## CITY OF COCONUT CREEK

### DEVELOPMENT REVIEW COMMITTEE (DRC) REVIEW #4 – AUGUST 04, 2025

<b>PROJECT NAME:</b>	Fifth Third Bank		
<b>PROJECT NUMBER:</b>	PZ-24090007		
<b>LOCATION:</b>	4805 Coconut Creek Parkway		
<b>APPLICANT/AGENT:</b>	BDG Architects		
<b>APPLICATION:</b>	Site Plan		
<b>DISCIPLINE</b>	<b>REVIEWER</b>	<b>EMAIL</b>	<b>TELEPHONE</b>
DRC Chair	Liz Aguiar - Assistant Director	<a href="mailto:laguiar@coconutcreek.net">laguiar@coconutcreek.net</a>	(954) 973-6756
Urban Design & Sustainability, Urban Design & Photometrics	Sustainable Development Manager		
	Linda Whitman - Sustainability Manager	<a href="mailto:lwhitman@coconutcreek.net">lwhitman@coconutcreek.net</a>	(954) 973-6756
Urban Design & Signage	Natacha Josiah - Planner	<a href="mailto:njosiah@coconutcreek.net">njiosiah@coconutcreek.net</a>	(954) 973-6756
Transportation	Michael Righetti - Senior Project Manager	<a href="mailto:mrighetti@coconutcreek.net">mrighetti@coconutcreek.net</a>	(954) 973-6756
Building	Sean Flanagan - Chief Building Official	<a href="mailto:sflanagan@coconutcreek.net">sflanagan@coconutcreek.net</a>	(954) 973-6750

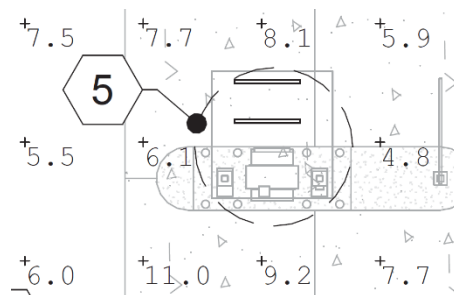
2. It appears that the photometric reading inside of the 5 foot zone of the night ATM is missing. Can a proposed reading to be added to ensure compliance with state statute?

RESPONSE: Photometric reading inside 5ft of the ATM is now showing.

Submittal #2 at 3'

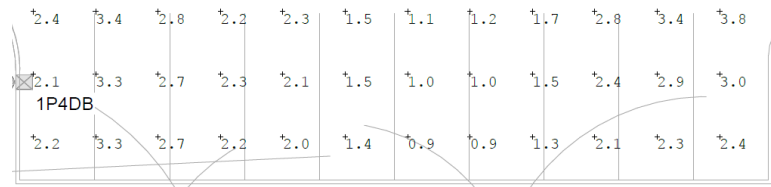
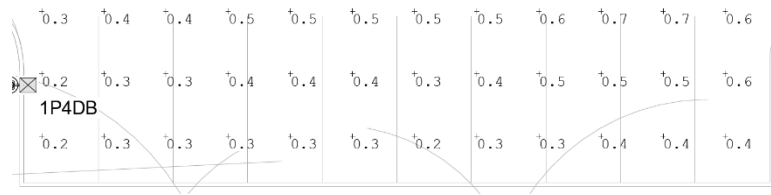
3. The light fixtures on the south parking area have been moved and caused a decrease in illumination. Per IES security lighting guidelines, parking lots where security is a concern should be illuminated to an average of 3.0 fc at grade and up to 5' with an average to minimum ratio of no greater than 4:1. Based on the 36 provided proposed readings, the south parking area is illuminated to an average of 2.2 fc with a ratio of 2.4:1 at 3' and an average of 0.4 fc with a ratio of 2:1 at grade. We recommend increasing the average fc reading in this parking lot at grade (which will in turn increase it at 3'). It is understood that code requires lighting to reduce to a maximum of 1fc after hours. We encourage the applicant to explore options such as motion sensors and dimmable lamps.

- Submittal #1 had 42 provided proposed readings with an average of 3.0 fc and a ratio of 1.6:1 at grade, which met IES security lighting guidelines and is why this was not discussed during that submittal. Comparison below:

- a. Response: Please refer to "ELECTRICAL PHOTOMETRIC SITE PLAN AT GRADE- OCCUPIED" and schedule on sheet E-011 for update foot candles per requirements. Photometric value measured at 3' is also updated on sheet E-012.

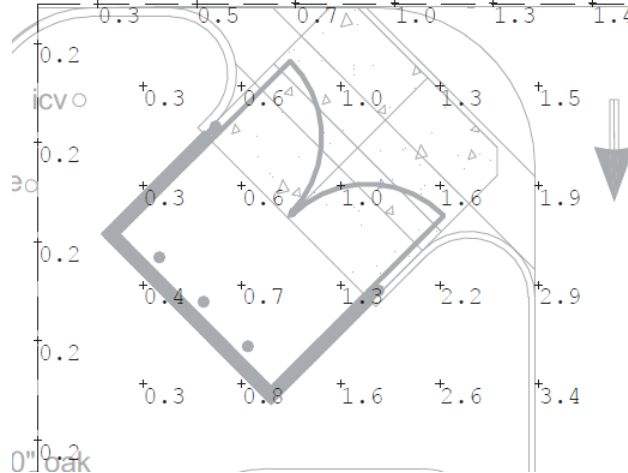
- Per IES security lighting guidelines, recommend that trash enclosures be illuminated to an average of 3 fc with an average to minimum ratio of no more than 4:1. Currently, based on readings below, enclosure has an average of 1.05 fc and an average to minimum ratio of 5.25:1.

- a. Response: Added note to the trash enclosure on sheet A-190
